SUBJECT: Former Castle Air Force Base Final Five-Year Review Report

SUBJECT: *Final* Five-Year Review, Fourth Five-Year Review Report  
Former Castle Air Force Base, California  
Contract FA8903-08-D-8777, Task Order 0144

**RESPONSES TO COMMENTS ON THE DRAFT FINAL FIVE-YEAR REVIEW, FOURTH FIVE-YEAR REVIEW REPORT,  
FORMER CASTLE AIR FORCE BASE, CALIFORNIA**

**Primary CERCLA Documents and  
Integration of Operable Units at the  
Former Castle Air Force Base**

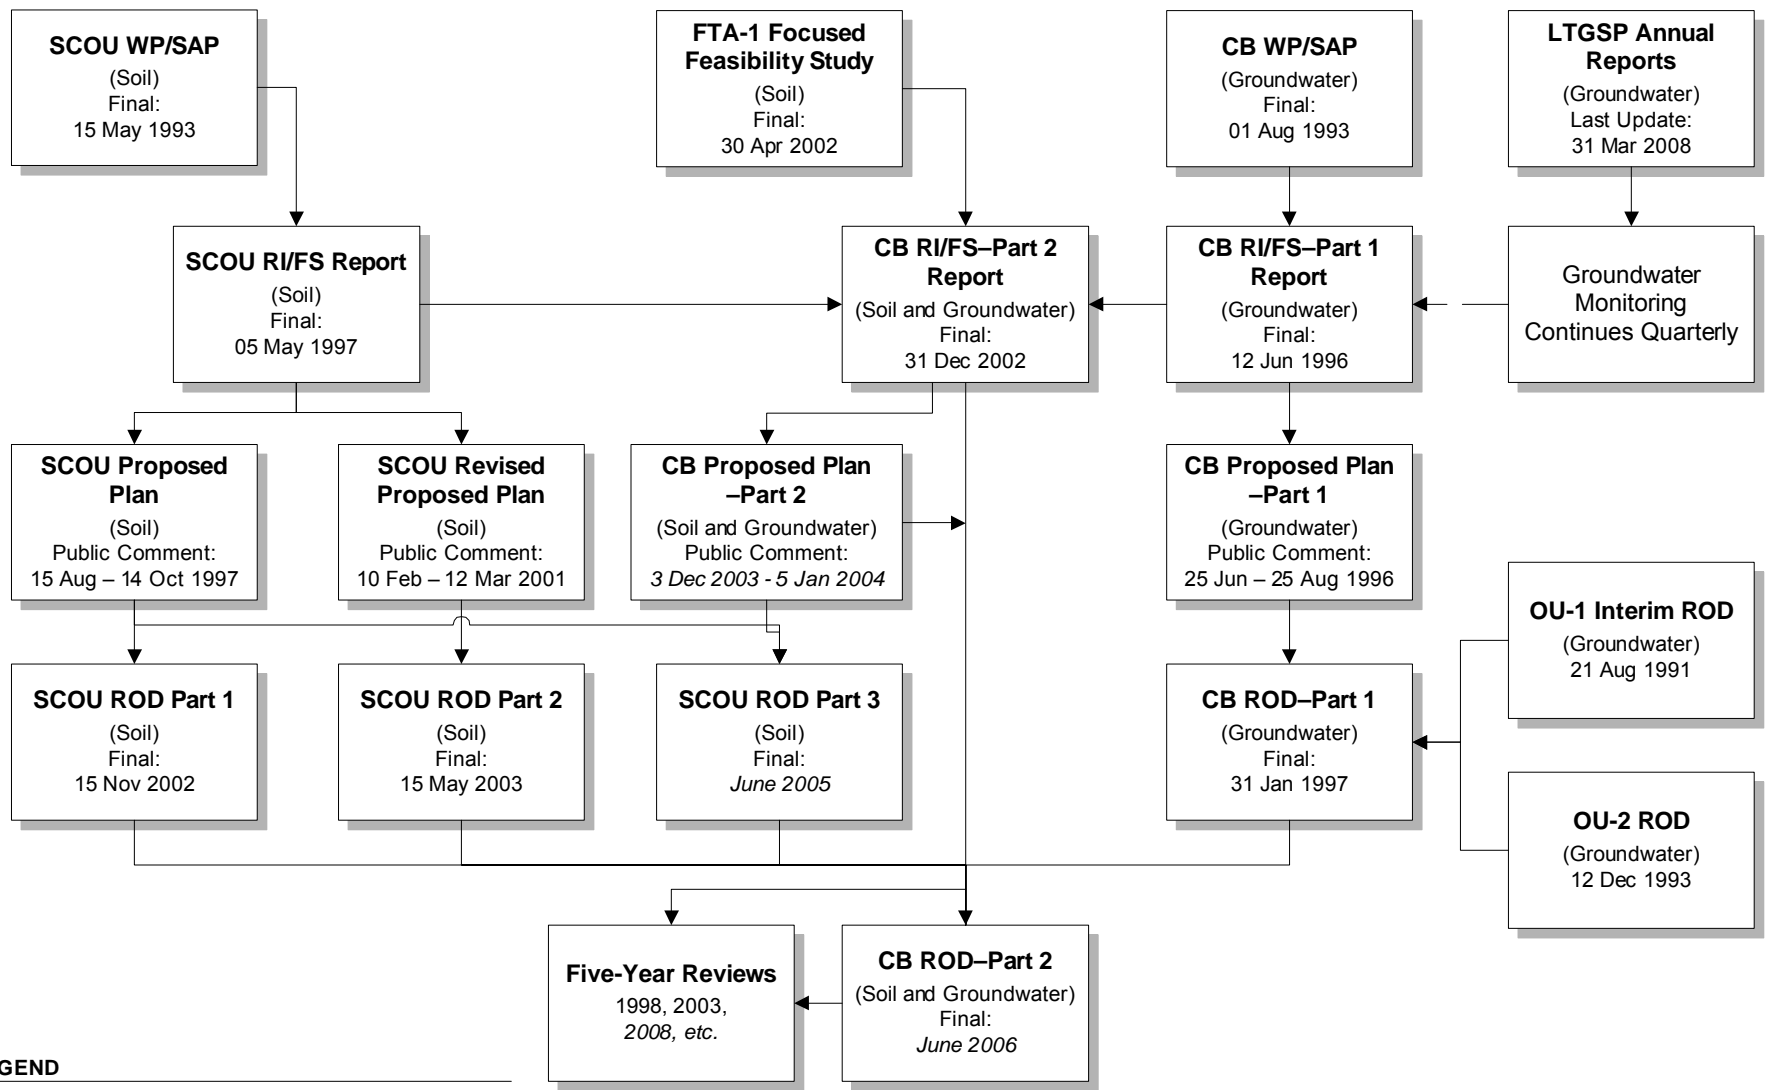
<b>Specific Comments</b>					
1	1.1 and Figure 2-1			<p><b>Section 1.1 Scope of Current Five-Year Review, and Figure 2-1, Primary CERCLA Documents and Integration of Operable Units at the Former Castle Air Force Base:</b> The description of RODs, OUs, and associated Sites maintained by the AF that are subject to the Fourth Five-Year Review needs clarification. The Review pertains to two OUs: The Groundwater OU and the Source Control OU (SCOU). However, multiple remedial actions and RODs have been established that may or may not be associated with this particular Review, since some Site remedial actions have been completed or the criteria for the remedial actions were superseded and/or amended by subsequent RODs. Further, while much of the Review discusses conditions at the Site</p>	<p>Section 1.1 outlines the five RODs that are currently applicable at the Former Castle Air Force Base and the sites that require review in this Five Year Review. The protectiveness evaluations in this Five Year Review are evaluated against the relevant ROD criteria. Each of the ROD remedies and associated criteria are summarized in Sections 4 and 7.</p> <p>As described in Section 1.1, there are only two OUs at Castle - Groundwater and Source Control. OUs are defined in the ROD documents and the integration of OUs and RODs is described in Section 1.1 and shown in Figure 2-1. The Interim OU-1 ROD and OU-2 ROD were superseded by the CB Part 1 ROD (see Section 2.2 of the CBP1 ROD). This will be stated in the CB Part 1 bullet in Section 1.1. It will also be stated that the</p>
